HERITAGE LANDING

SITE PLAN #09-21 & CONDITIONAL USE PERMIT #08-21

STAFF REPORT

Re: Town of Hudson Planning Board Review
Heritage Landing Site Plan, 112 & 114 Greeley Street
Tax Map 140 Lots 2 & 3; Acct. #1350-969
Reference No. 20030249.2050

DATE: JUNE 1, 2021 SCALE: 1"=40'
 PROJECT NO: 20-1001-1 SHEET 7 OF 29

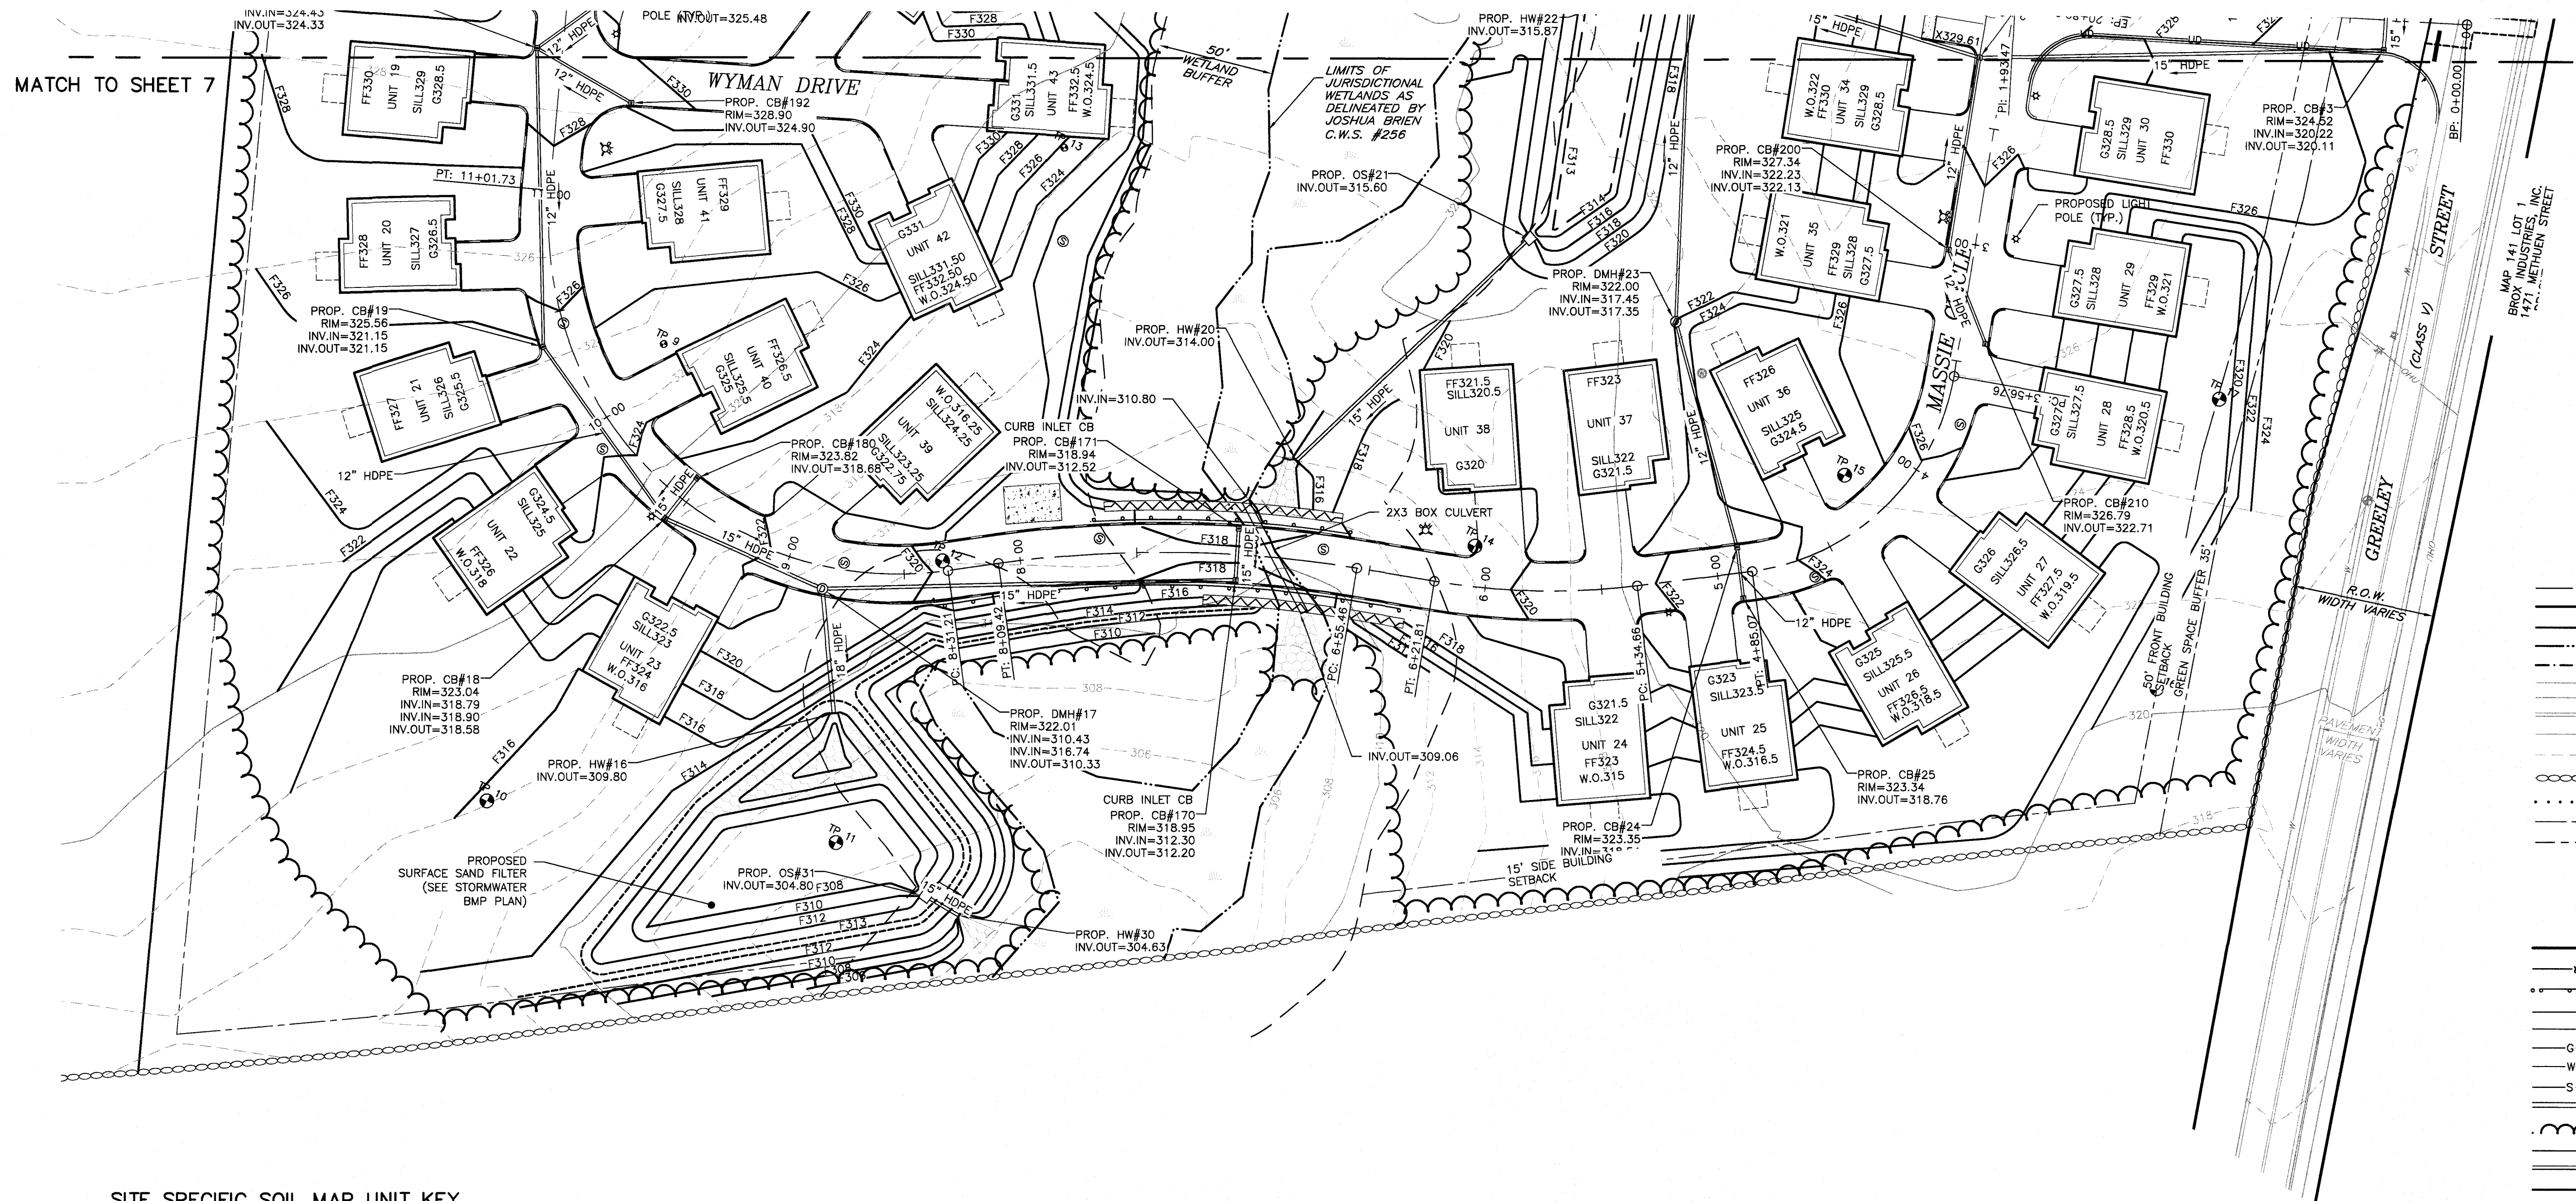
- m. ETGTD 930.13. The applicant should add underdrains in all cut sections of the proposed roadway profile plan sheets.
- n. ETGTD 930.15. The applicant should revise the DMH detail on Plan Sheet #24 to reference the Town required DMH cover.

Underdrains have been added to areas of cut on the proposed roadway, and can be seen on sheet 7 GRADING & DRAINAGE PLAN.

PRECAST REINFORCED DRAIN MANHOLE DETAIL
NOT TO SCALE
(MARCH 2008)

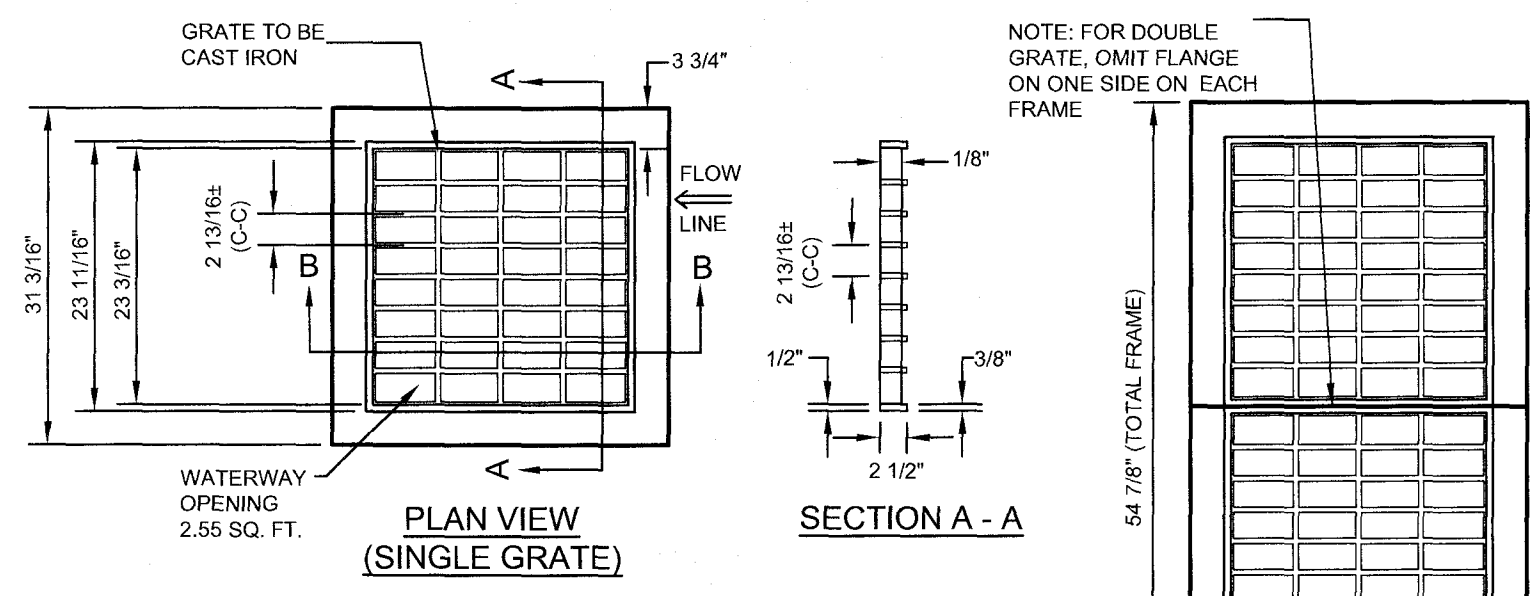
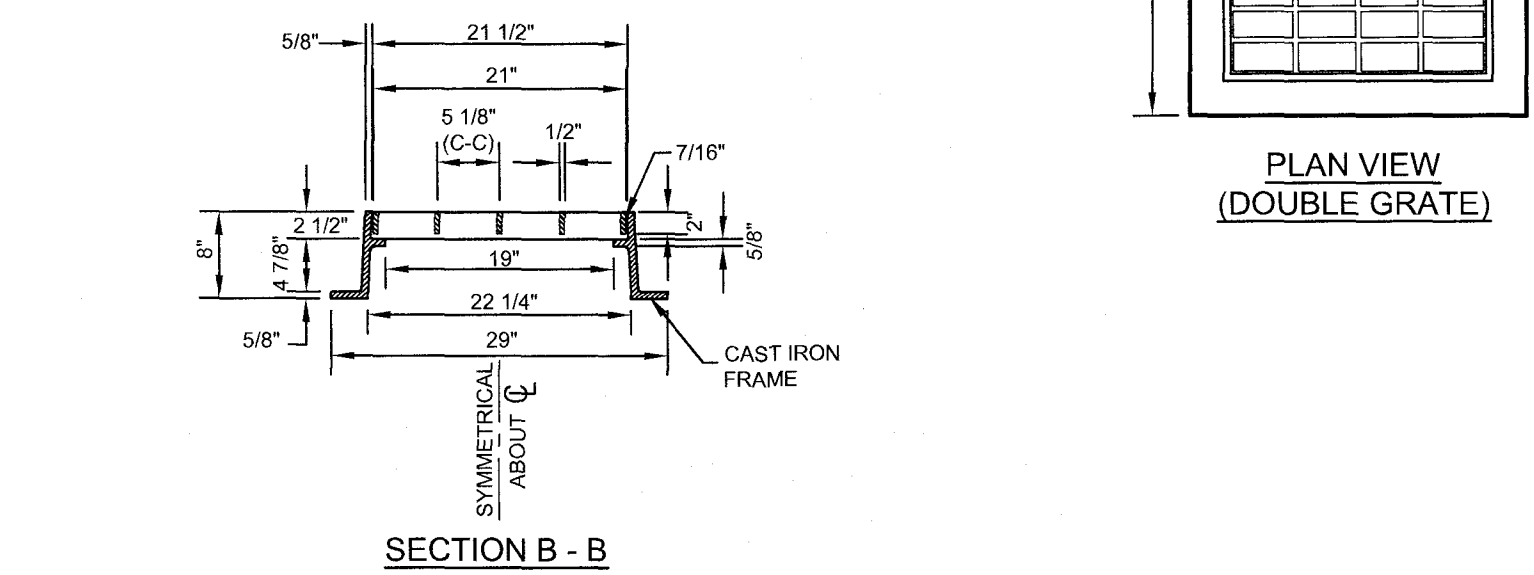
- n. ETGTD 930.15. The applicant should revise the DMH detail on Plan Sheet #24 to reference the Town required DMH cover.

The DMH detail on sheet 24 has been updated to reference the Town required DMH cover.

OUTLET STRUCTURE #21
NOT TO SCALE

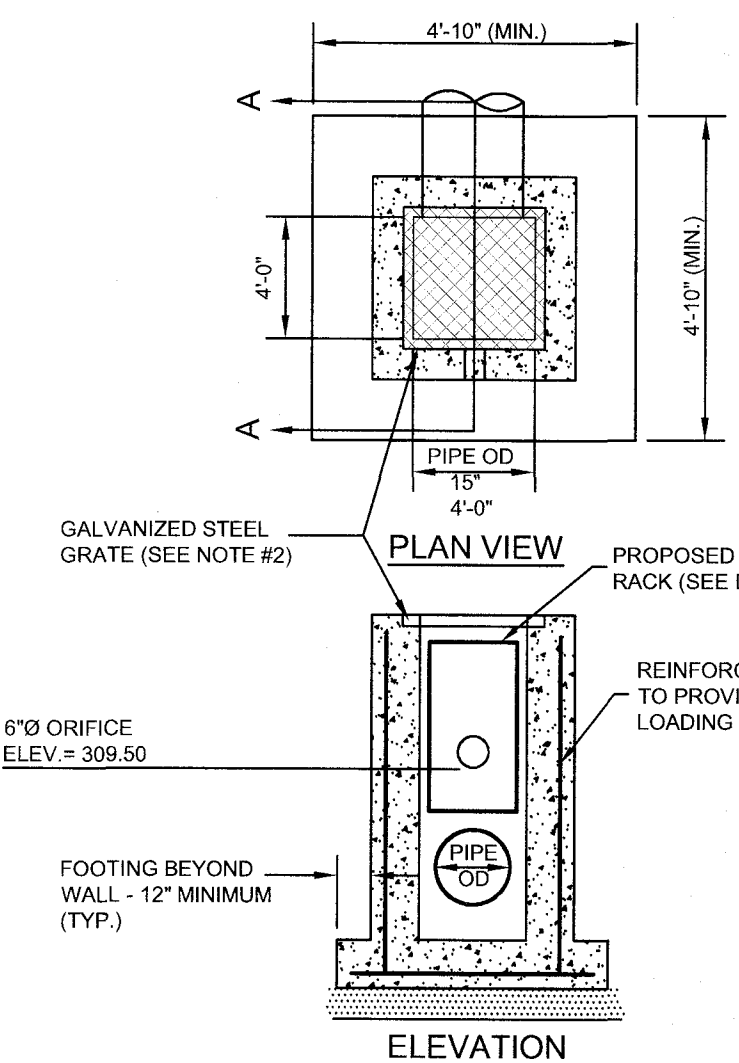
- o. ETGTD 930.30. The applicant should coordinate the outlet elevation of the 15" pipe between the Outlet Structure #21 detail upon Plan Sheet 25 with the HydroCAD Pond 1P.

Outlet Structure #21 detail on sheet 25 has been updated to match both the plans and the HydroCAD model.

UTILITY SEPARATION (MAIN) DETAIL
(A-01)
NOT TO SCALE
(MARCH 2008)

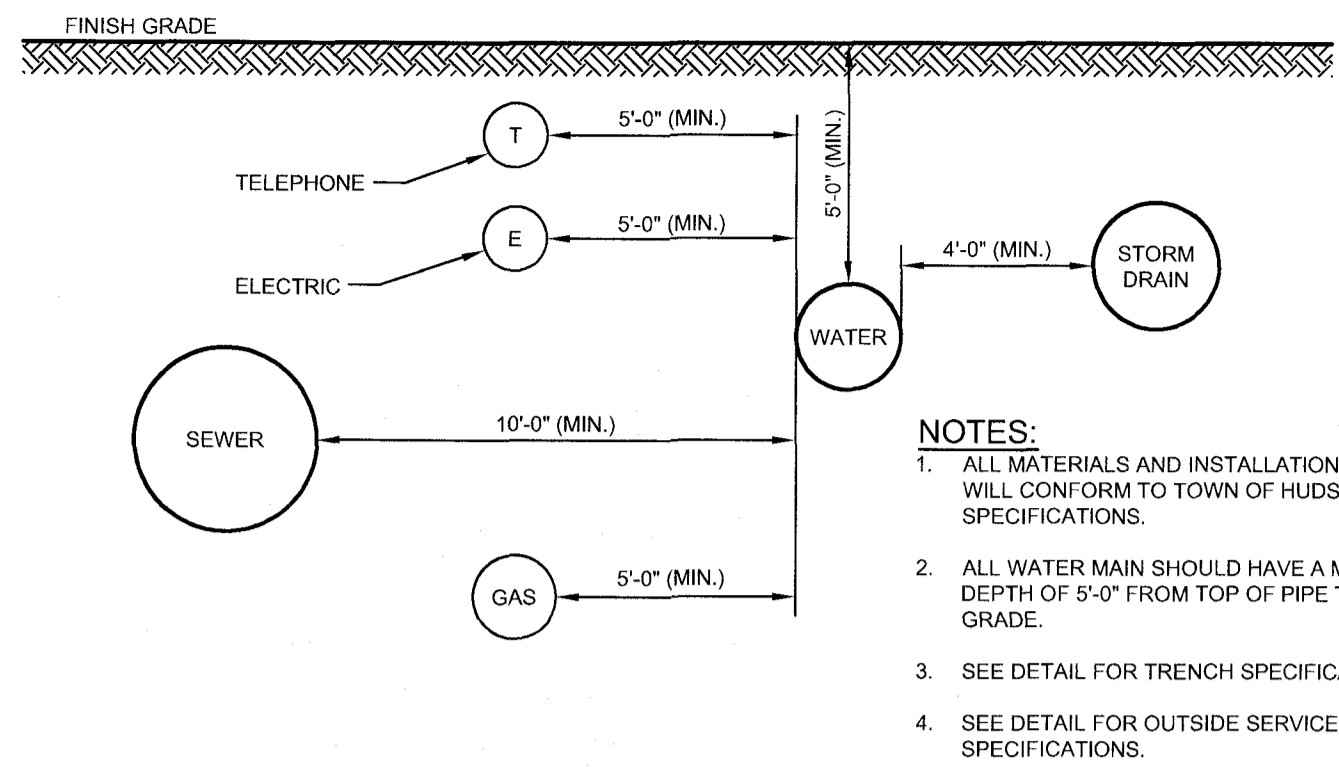
- c. HR 276-13. The applicant should provide a detail for water/sewer/drain utility crossings on the plan set.
- d. HR 276-13. The applicant has shown very steep pipe slopes from SMH #111 and STR #23 into the sewer pump station. The applicant should provide pipe anchors for any slopes exceeding 15%, and also verify that flow velocities conform to the requirements of NHDES Env-Wq 704.04(i).

- c. HR 276-13. The applicant should provide a detail for water/sewer/drain utility crossings on the plan set.
The UTILITY SEPARATION (MAIN) DETAIL is located on sheet 26.

HYDRANT INSTALLATION
(A-10)
NOT TO SCALE
(MARCH 2008)

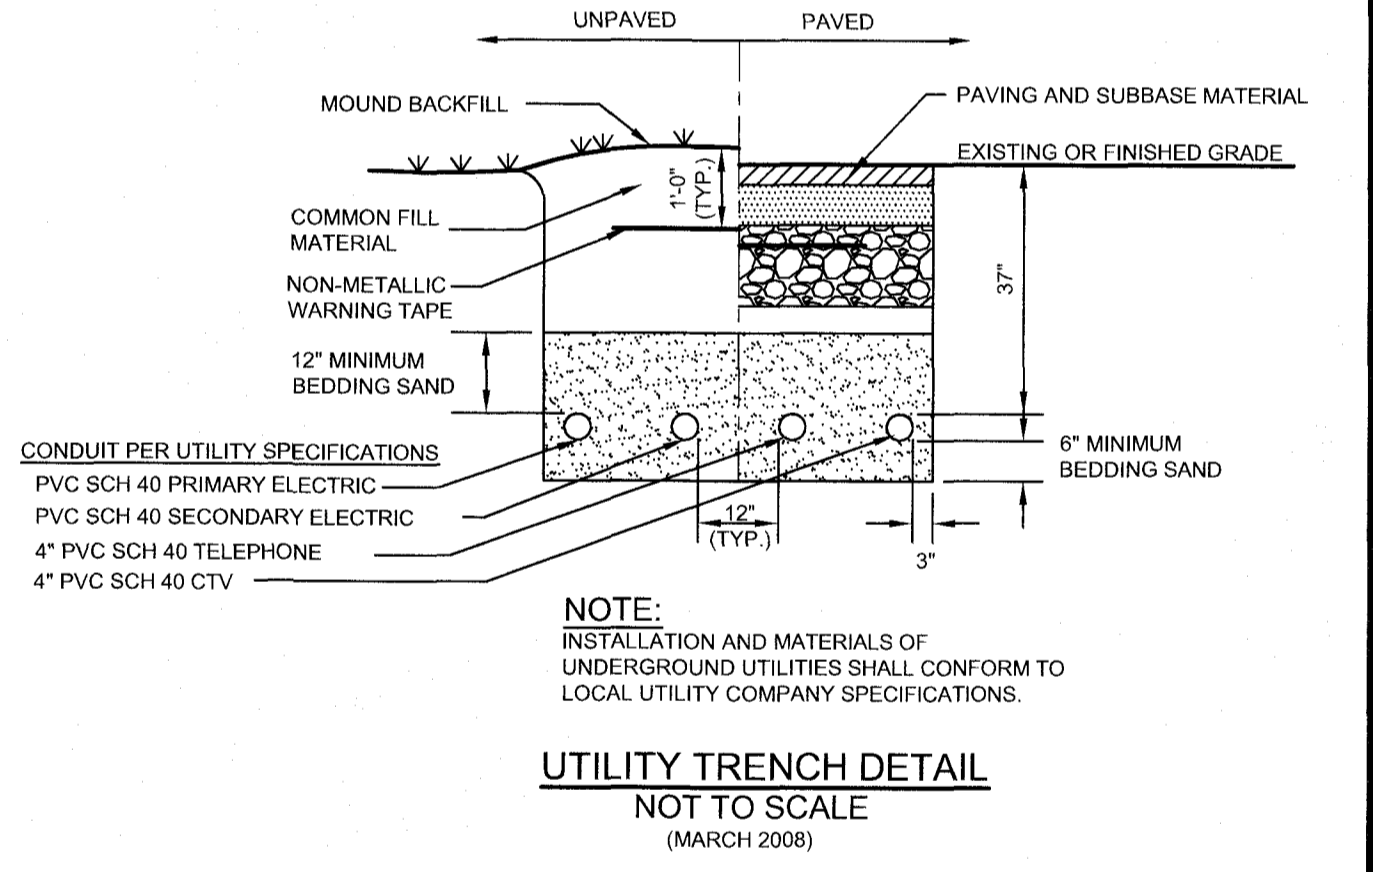
- e. ETGTD Section 825.2.13. The applicant has noted 'Approved Fire Hydrant' on the Hydrant Installation detail but has not noted the proposed hydrant brand or model. Hydrant models approved for use in Hudson are included in the referenced technical specification.
